Nest Buffer Reduction Request #12

Subject: Mitigation Measure (MM) Biology-7 Nest Buffer Reduction Request

Sycamore to Peñasquitos 230 kV Transmission Line Project Nesting Bird Buffer Reduction Request

**Sycamore to Peñasquitos
230kV Transmission Line Project
Nesting Bird Survey
Buffer Reduction Request**

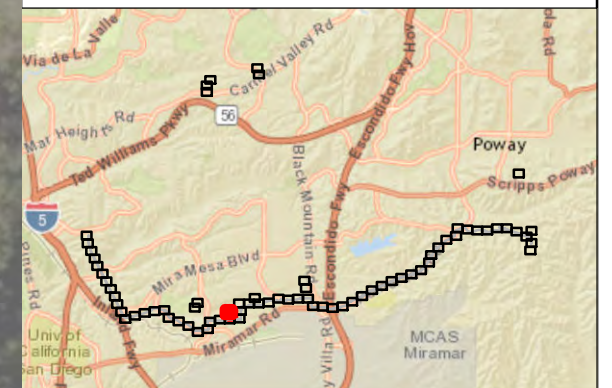
One new common bird species nest has been identified on the perimeter of the Hanson Staging Yard. The nest was observed during regular environmental compliance inspection of the active yard. The attached table contains the following information for the recorded nest SDG&E is requesting a buffer reduction for:

Also, attached please find a map showing the location of the documented nest, the standard nest buffer limits identified in MM Biology-7, and the reduced buffer limits being recommended by the Qualified Biologist. Please note that no ground disturbing or vegetation clearing activities are occurring at this staging yard location, the biologist has established a buffer around the nest to prevent any direct disturbance to the nest.

As this nest was found in an active construction area, SDG&E has implemented the buffer reduction recommended by the Qualified Biologist. The nest will be monitored on a daily basis during construction activities. If the buffer request is denied, or the Qualified Biologist determines that the nesting bird(s) are not tolerant of ongoing project activities, the specified buffer(s) listed in MM Bio-7 will be implemented.
